SUNDRY NOTICES AND REPORTS ON WELLS

5. Lease Serial No.
LC029489B
6. If Indian, Allottee or Tribe Name
7. If Unit or CA/Agreement, Name and/or No.
8. Well Name and No.
Central Corbin Queen Unit #205
9. API Well No.
30-025-29453
10. Field and Pool, or Exploratory Area
Corbin Queen Central
11. County or Parish, State
Wm

OXY USA Inc. - Current
Central Corbin Queen Unit #205
API No. 30-025-29453

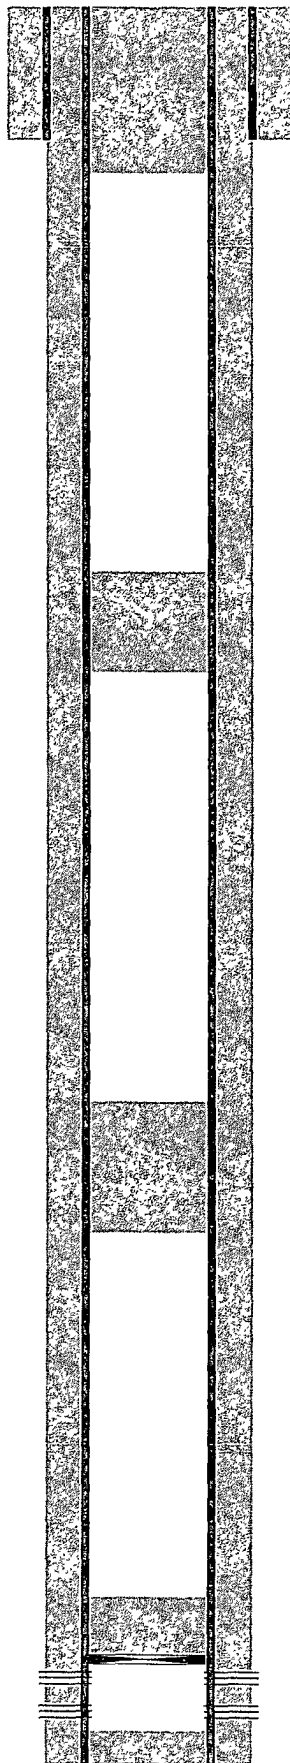
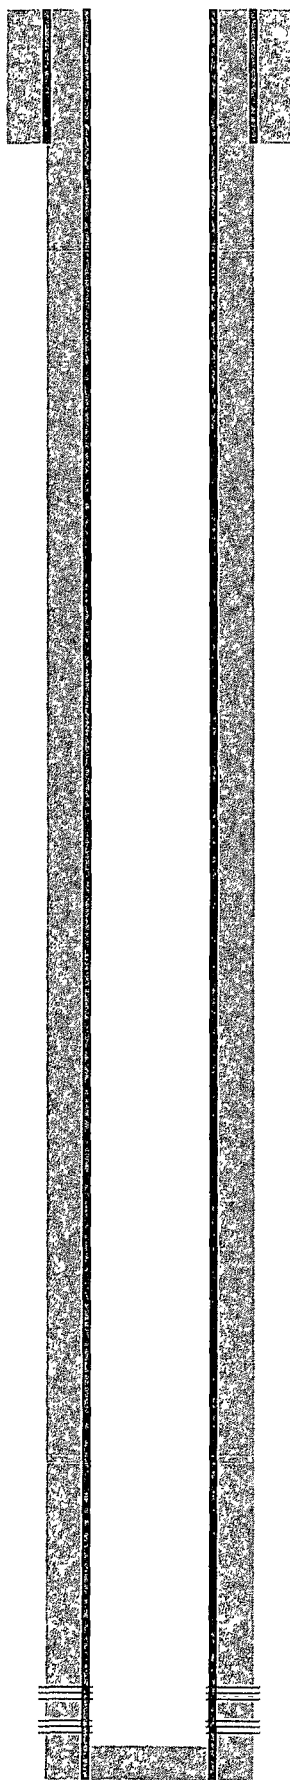
CIBP 4087
Existing in place

Drill out set @
4/25 ap.
